Access Compliance Report

Public Rights-of-Way

Intersection ID: 53928	Main Street: PRESTON_KNOLL_LN	Cross Street: PINYON_PINE_LN	Location: NW
ADA ID: 372BADD11078	Ramp Type: BlendTrans1	Initial Pass/Fail: Fail	Overall Compliance: No
			Severity Score: 36.25

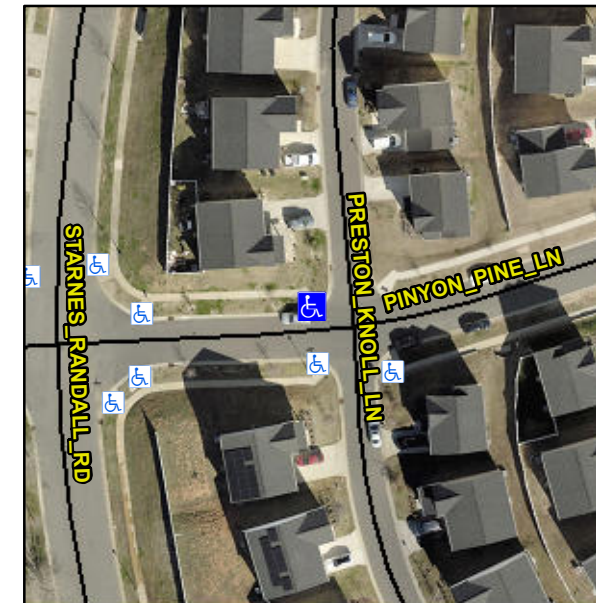
Not Found, R304.5.1, R304.5.3

Compliance	Description	Data	Compliance	Description	Data
N/A	Ramp Length (in)	93.5	Yes	BlendTrans Slope (%)	1.5
No	Ramp Width (in)	30.0	No	BlendTrans XSlope (%)	2.6
N/A	Flare Type LT	N/A	N/A	Flare Type RT	N/A
N/A	Flare Slope LT (%)	N/A	N/A	Flare Slope RT (%)	N/A
N/A	Flare Traversable LT?	N/A	N/A	Flare Traversable RT?	N/A
N/A	Landing Length (in)	N/A	N/A	DWS Provided?	N/A
N/A	Landing Width (in)	N/A	N/A	DWS Contrast?	N/A
N/A	Landing Slope (%)	N/A	N/A	DWS Length (in)	N/A
N/A	Landing X Slope (%)	N/A	N/A	DWS Full Width?	N/A
N/A	Landing Curb? (Y/N)	N/A	N/A	DWS Offset (in)	N/A
N/A	Shared Landing?	N/A			
N/A	Gutter Ponding?	N/A	N/A	Gutter Slope (%)	N/A
N/A	Gutter Lip Ht (in)	N/A	N/A	Gutter X Slope (%)	N/A
N/A	Painted X Walk1?	No	N/A	Painted X Walk2?	No
	X Walk 1 Direction	To S		X Walk 2 Direction	To E
	X Walk 1 Width (in)	N/A		X Walk 2 Width (in)	N/A
	X Walk 1 Slope (%)	4.1		X Walk 2 Slope (%)	6.2
	X Walk 1 X Slope (%)	5.9		X Walk 2 X Slope (%)	3.5

Remove & Replace Curb Ramp With Two New Directional Ramps or Equivalent.
